**Detailed Site Plan**  
**Departure from Design Standards**  
**Alternative Compliance**  
**PMG Brooks Drive**

**DSP-20016**  
**DDS-670**  
**AC-20009**

STAFF REPORT

SUBJECT:      Detailed Site Plan DSP-20016  
                 Departure from Design Standards DDS-670  
                 Alternative Compliance AC-20009  
                 PMG Brooks Drive

Figure 1: Site Development Plan

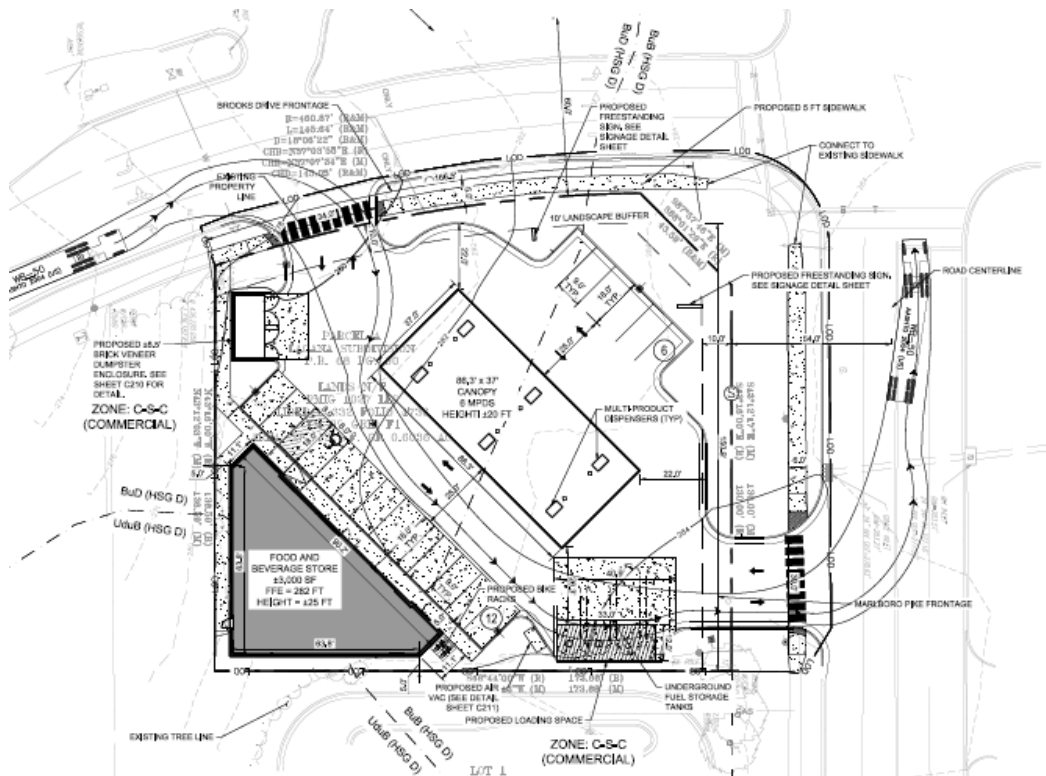
Half of the existing vehicular access points to the site are removed, with two points of access retained, one at the far western corner of the site, to Brooks Drive, and second at the far eastern corner of the site, to Marlboro Pike. Pedestrian and bicycle access to the building is provided by a sidewalk from Brooks Drive only. The provision of a pedestrian connection between the building and Marlboro Pike is also appropriate, but is not reflected on the DSP. A condition has been included in the Recommendations section for the provision of this pedestrian connection. A standard five-foot-wide sidewalk is provided along Brooks Drive and a six-foot-wide sidewalk is provided along Marlboro Pike. A total of 18 parking spaces are provided and the departure submitted requests to reduce the size of parking spaces to 9 feet by 18 feet, as discussed in Finding 7 below.

As shown on the plan, a five-foot-wide sidewalk provides a complete pedestrian connection between the proposed food and beverage store building and Brooks Drive. However, in reviewing this requirement relative to the site design guidelines contained in Section 27-274 of the Zoning Ordinance, as cross-referenced in Section 27-283 of the Zoning Ordinance, staff recommends that a clearly defined pedestrian connection also be provided between the building and Marlboro Pike. It is important to have one in this area as there is a bus stop along Marlboro Pike in front of the adjacent property, so there will be pedestrian traffic along this roadway in need of safe access into the site and to the building. A condition requiring such a connection to serve pedestrian traffic is included in the Recommendation section.

- 1. Prior to certification, the detailed site plan shall be revised, or additional information shall be provided, as follows:
    - a. Provide a pedestrian connection, in the form of sidewalks, pavement markings, or other facility, from Marlboro Pike to the entrance of the food and beverage store.

*Figure 2: Food and Beverage Store Elevations*

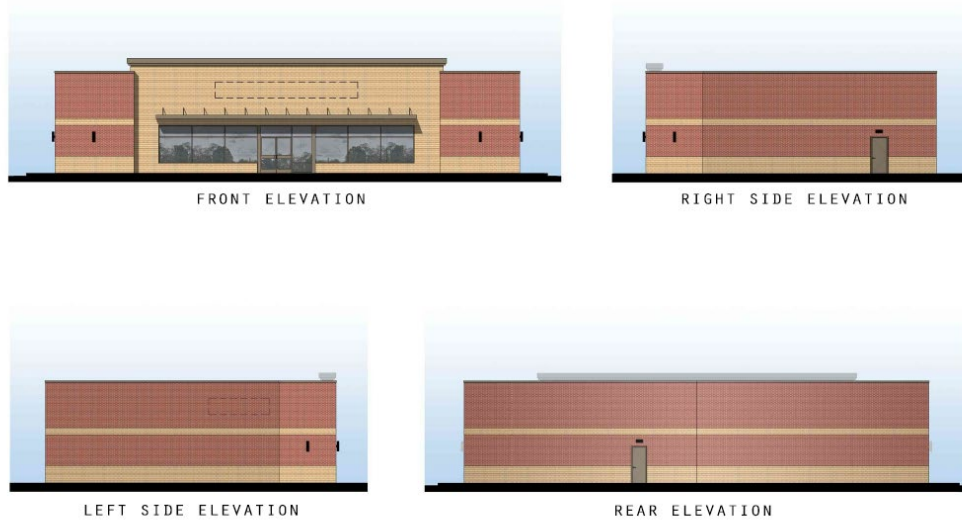
The proposed 3,000-square-foot food and beverage store is a 25-foot-high, single-story, triangular-shaped structure. The front façade of the building faces north, toward the interior of the site. Building elevation drawings do not provide dimensional data or details regarding façade treatments. A condition has been included in the Recommendation section for the plan to be revised to provide this information. Based on the elevations as submitted, appropriate fenestration is provided on the front façade, with no windows provided elsewhere on the building. Given the proposed use and configuration of the building on the site, the location and quantity of fenestration provided is acceptable. A raised cornice and lighter material coloration provided in the middle of the front façade adds interest to the design.

Architectural elevations of each façade of the proposed building and gas station canopy were provided. The images show structures that are compatible with existing development in the surrounding area. Complete details regarding the building's architecture, such as a schedule of exterior finishes, was not provided. A condition has been included in the Recommendation section to require the DSP to be revised to include this information.

- b. Provide dimensional data and labels of features and materials on all architectural elevations for the food and beverage store.
    - c. Revise the plan and signage table to include gas station canopy mounted signage data and demonstrate canopy mounted signage conforms with Section 27-613(c) of the Prince George's County Zoning Ordinance.

Figure 4: Signage Examples

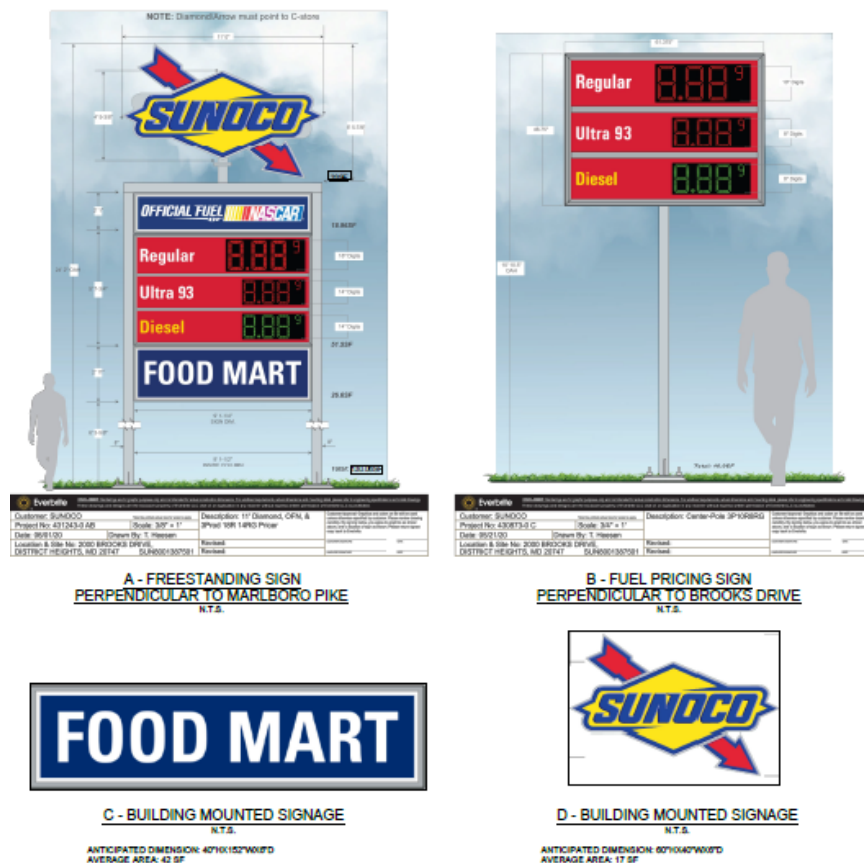
A comprehensive signage program is provided that includes freestanding, canopy-mounted, and building-mounted signs for the proposed gas station and food and beverage store. Building-mounted signage is designed in conformance with Section 27-613 of the Zoning Ordinance. Canopy-mounted signage area is not provided on the DSP and appears greater than permissible by Section 27-613(c). Details are provided for two freestanding signs, one with fuel pricing only, and a second larger sign with fuel pricing and business identity and advertising. Locations for both freestanding signs are shown adjacent to the intersection of Brooks Drive and Marlboro Pike. The second, smaller sign with fuel pricing only is permissible per Section 27-594(a) of the Zoning Ordinance, which requires a price sign at each entrance to the station. It is also in conformance with the requirements of Section 27-614(c)(6) of the Zoning Ordinance, relative to allowed area. A condition has been included in the Recommendation section for the signage plan to be revised to conform with Section 27-613.
